Access Compliance Report

Public Rights-of-Way

(Curb Ramps)

Intersection ID: 10033070	Main Street: NORTH_COMMUNITY_HOUSE_RD	Cross Street: N/A	Location: SW
ADA ID: 464F8C787615	Ramp Type: Para	Initial Pass/Fail: Fail	Overall Compliance: No
Severity Score: 13.75			
Codes/Mitigation Info/Possible Solution		Field Measurements/Component Compliance

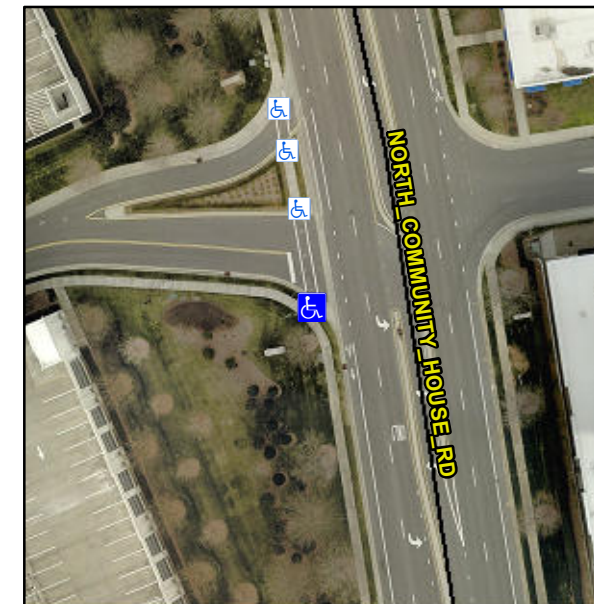
R304.5.3, R304.3.2

Compliance	Description	Data	Compliance	Description	Data
N/A	Ramp Length LT (in)	54.0	N/A	Ramp Length RT (in)	63.0
Yes	Ramp Width LT (in)	58.5	Yes	Ramp Width RT (in)	58.0
Yes	Ramp Slope LT (%)	8.2	No	Ramp Slope RT (%)	9.5
No	Ramp XSlope LT (%)	2.1	Yes	Ramp XSlope RT (%)	2.0
N/A	Landing Length (in)	N/A	N/A	DWS Provided?	N/A
N/A	Landing Width (in)	N/A	N/A	DWS Contrast?	N/A
N/A	Landing Slope (%)	N/A	N/A	DWS Length (in)	N/A
N/A	Landing X Slope (%)	N/A	N/A	DWS Full Width?	N/A
N/A	Landing Curb? (Y/N)	N/A	N/A	DWS Offset (in)	N/A
N/A	Shared Landing?	N/A			
N/A	Gutter Ponding?	N/A	N/A	Gutter Slope (%)	N/A
N/A	Gutter Lip Ht (in)	N/A	N/A	Gutter X Slope (%)	N/A
N/A	Painted X Walk1?	Yes	N/A	Painted X Walk2?	N/A
	X Walk 1 Direction	To NW		X Walk 2 Direction	N/A
N/A	X Walk 1 Width (in)	75.0	N/A	X Walk 2 Width (in)	N/A
	X Walk 1 Slope (%)	1.3		X Walk 2 Slope (%)	N/A
	X Walk 1 X Slope (%)	4.0		X Walk 2 X Slope (%)	N/A
N/A	Ramp inside XWalk1?	Yes	N/A	Ramp inside XWalk2?	N/A

Remove & Replace Entire Ramp.
